The City of Spartanburg Design Review Board

AGENDA

August 1, 2023, at 5:30 P.M.

The Design Review Board (DRB) has received a request for Preliminary conceptual approval of a buildings form, massing and placement on the site for the proposed Spartanburg County Public Library – Headquarters Expansion and Planetarium located in the DT Zone (Civic District) at 151 S. Church Street (Tax Map Sheet: 7-12-21-074.00). Owner: Spartanburg County Library / Applicant: Adam Flynn and Sarah Stevens, McMillan Pazdan Smith.
- IX. Selection of Chair / Vice Chair.**
- X. Staff Announcements:**

SETBACK FROM CORNER AND FRONT OF LOT

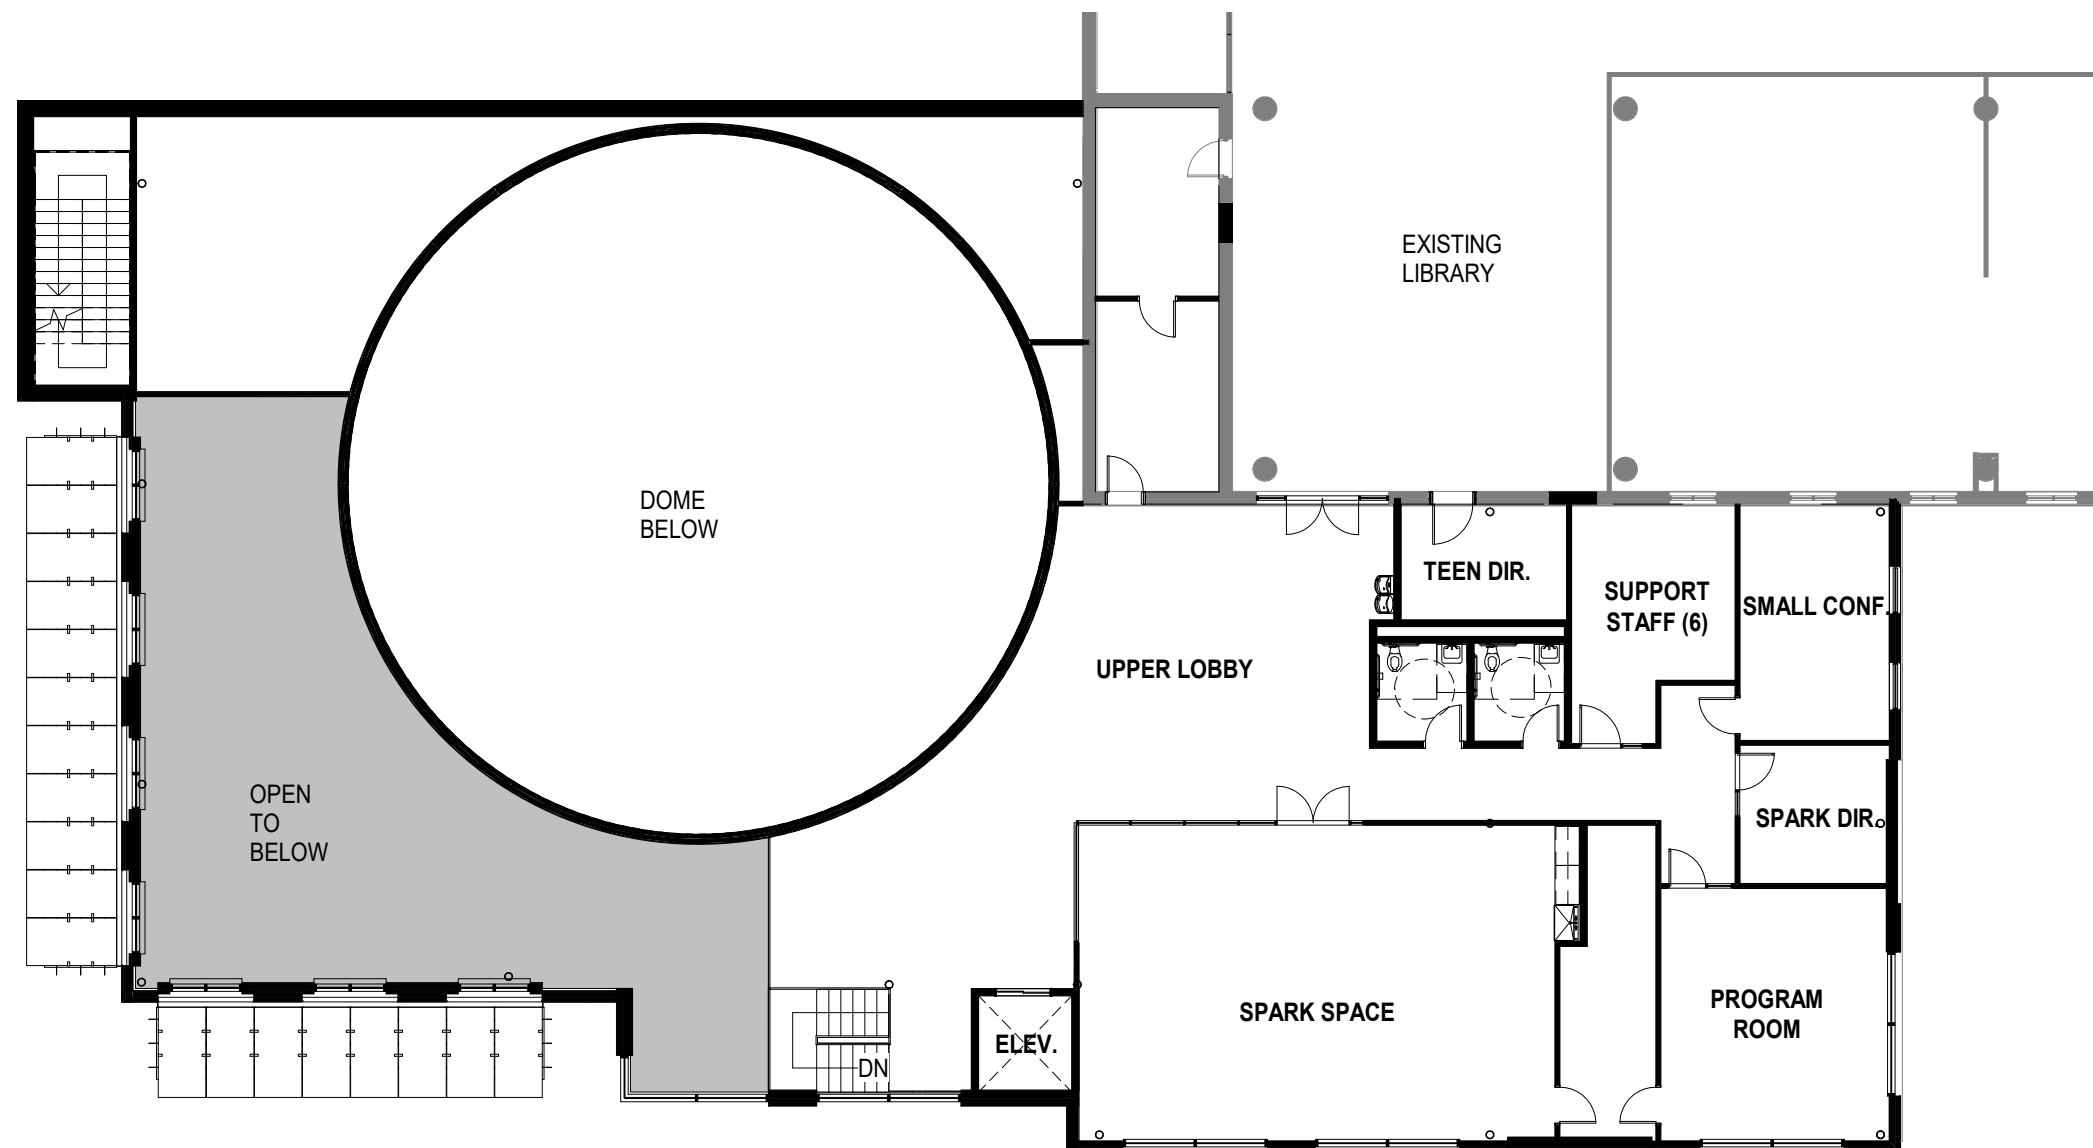
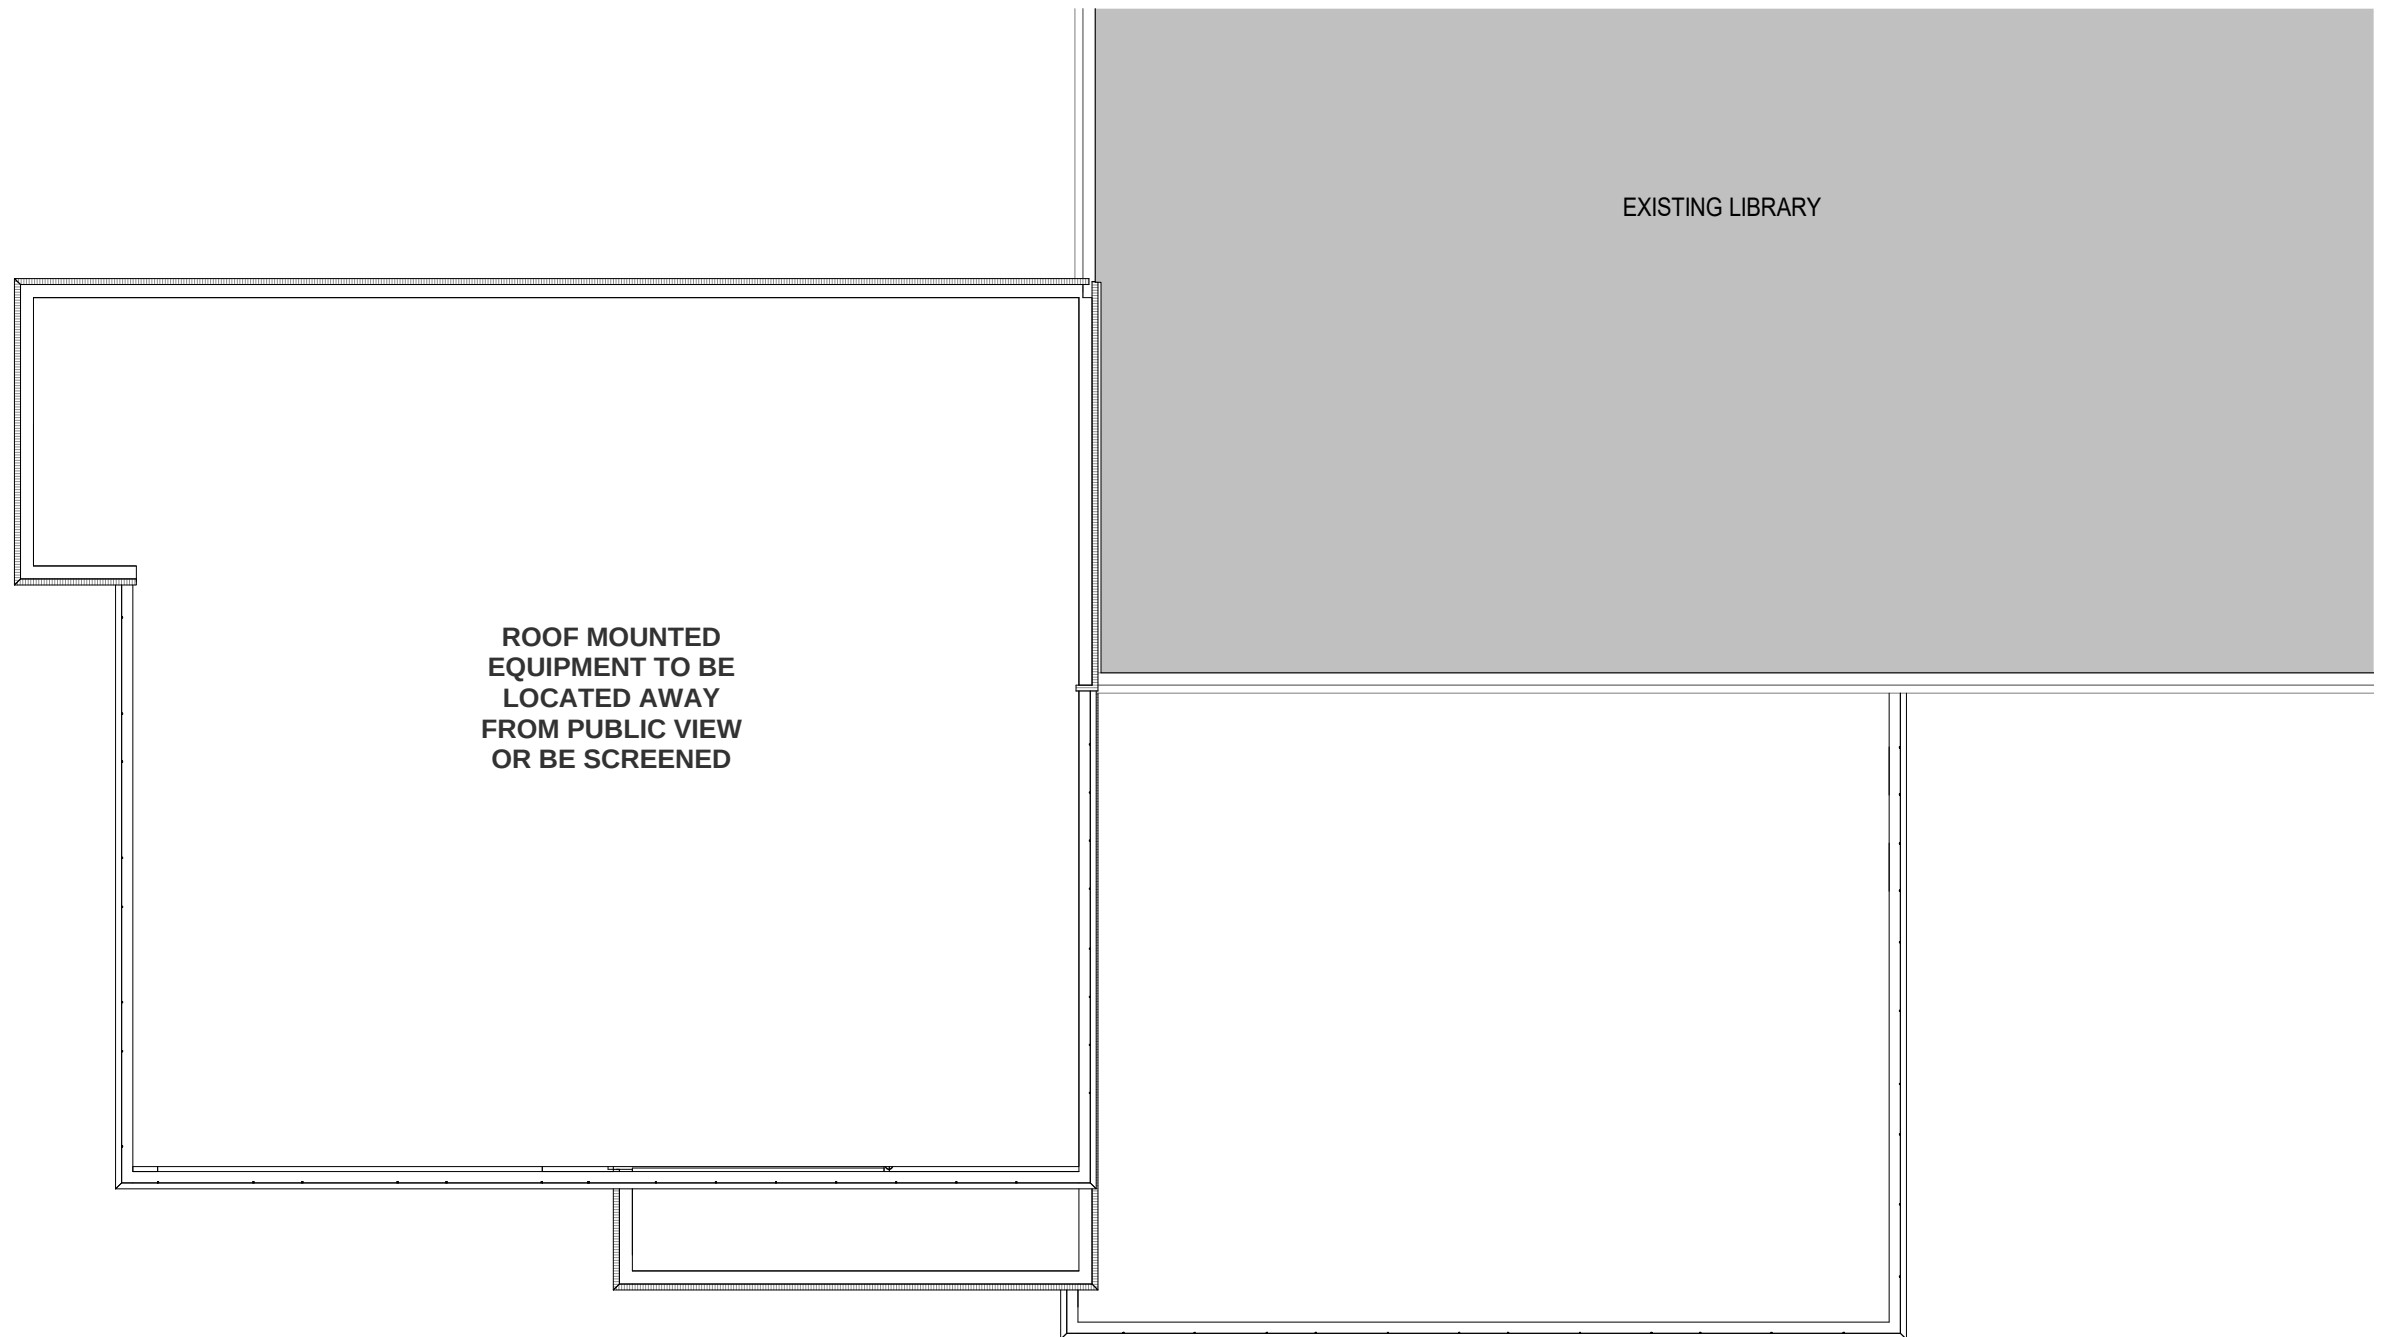
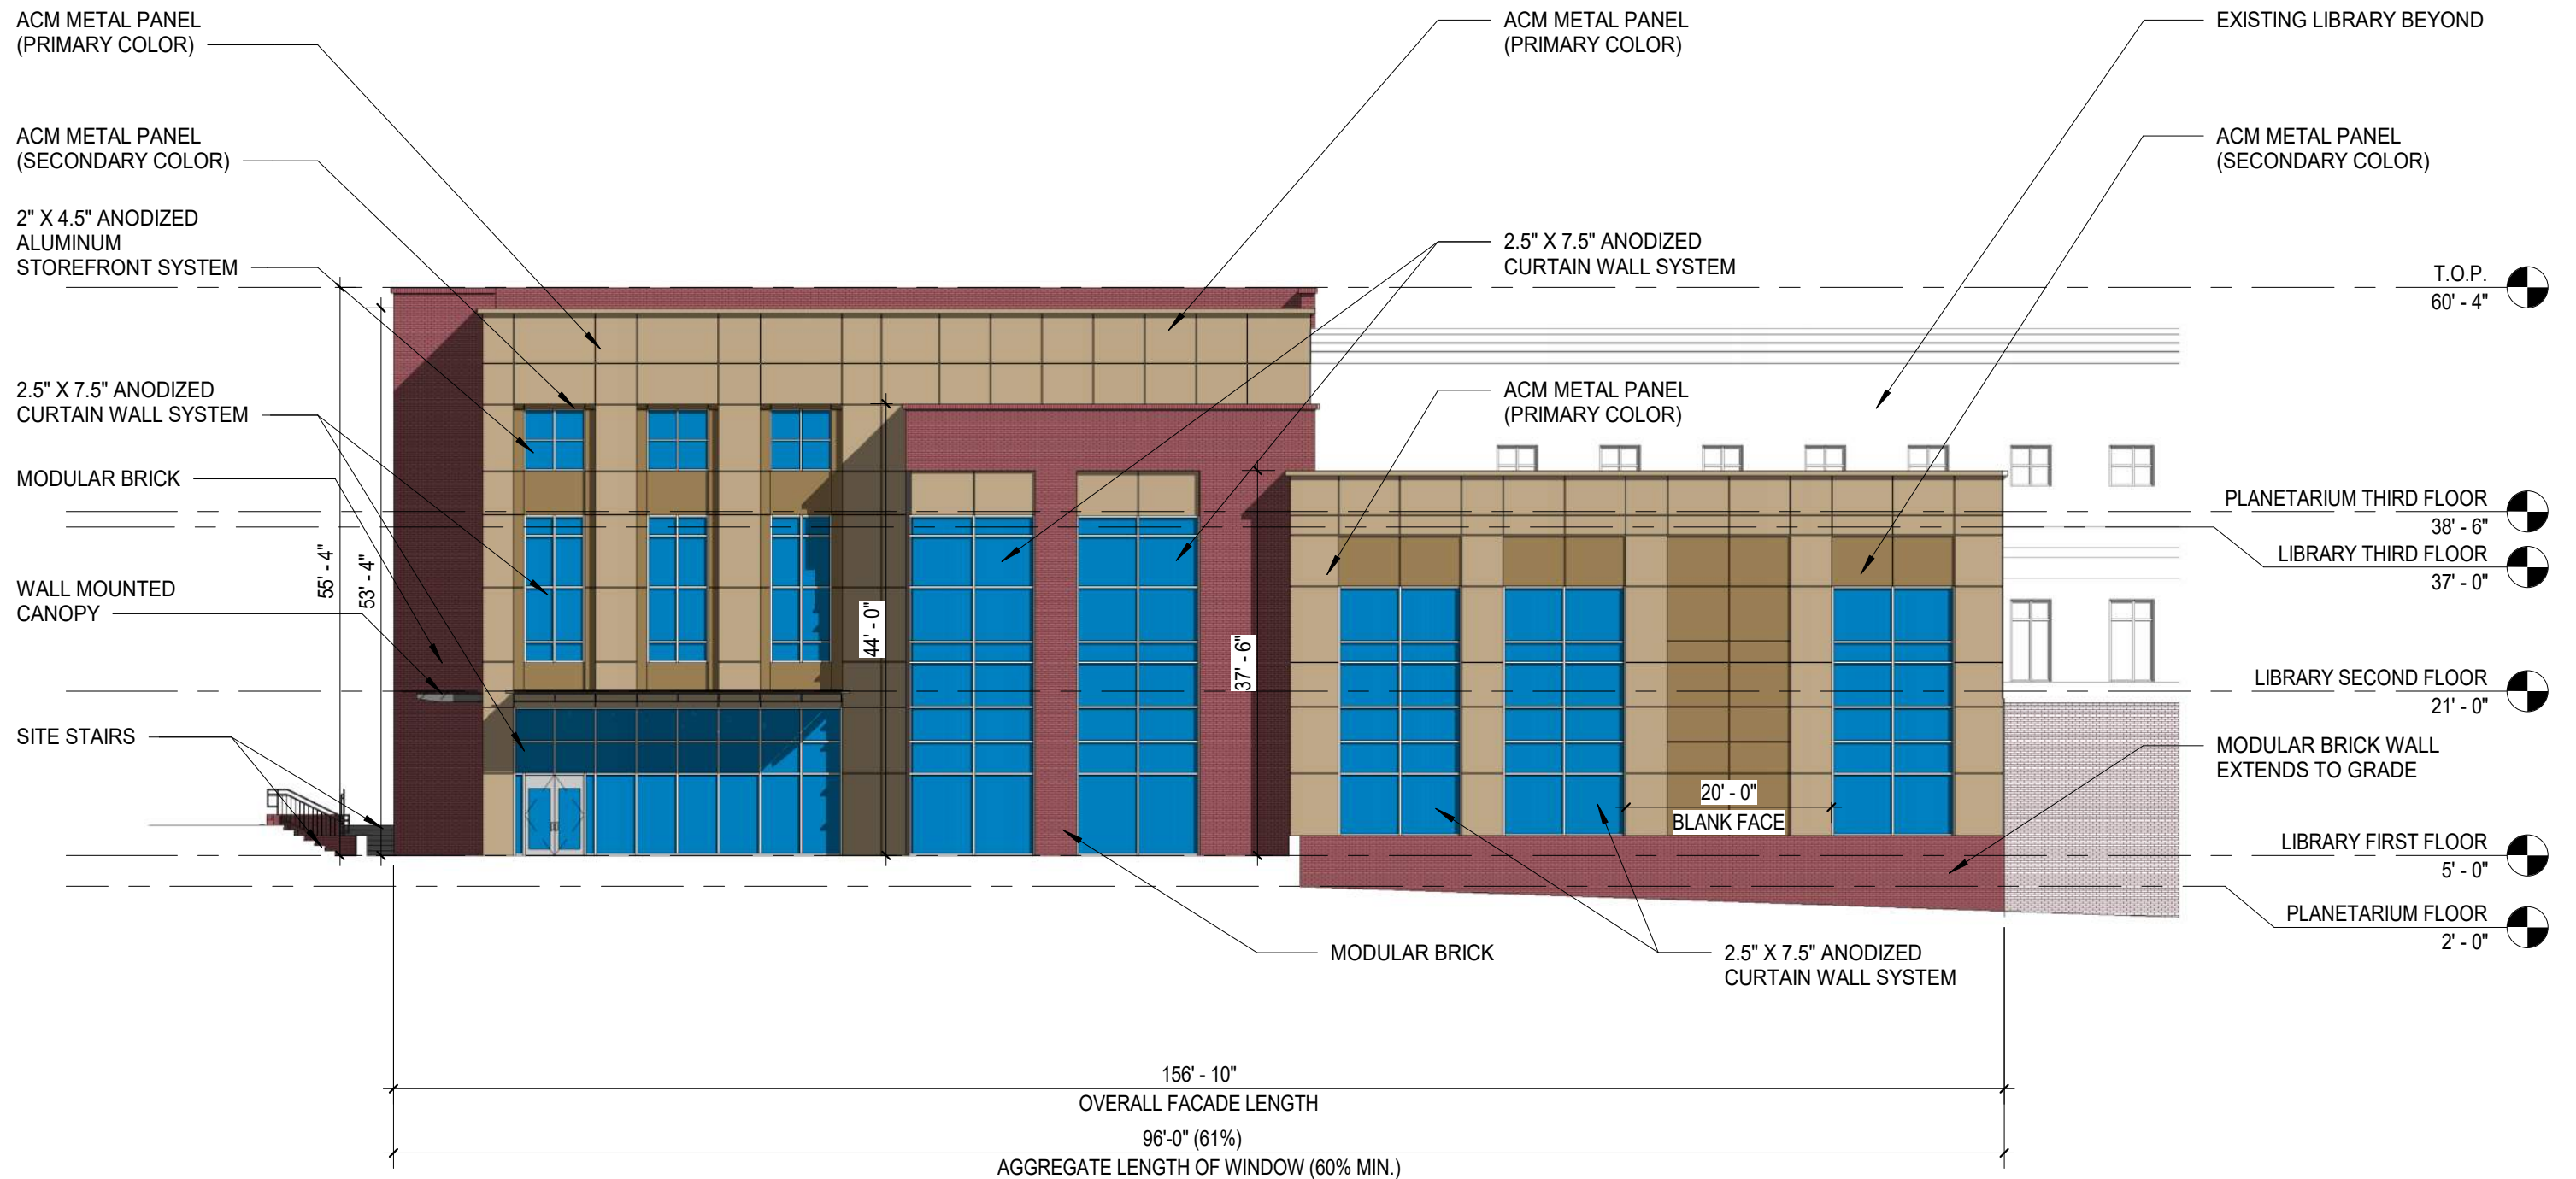
AS AN ADDITION TO A CIVIC BUILDING WE ARE ASKING FOR A VARIANCE TO EXCEED THE 12' SETBACK AND ALLOW FOR A PUBLIC PLAZA AND PLANTINGS THAT ACCENT OUR CORNER ENTRY.
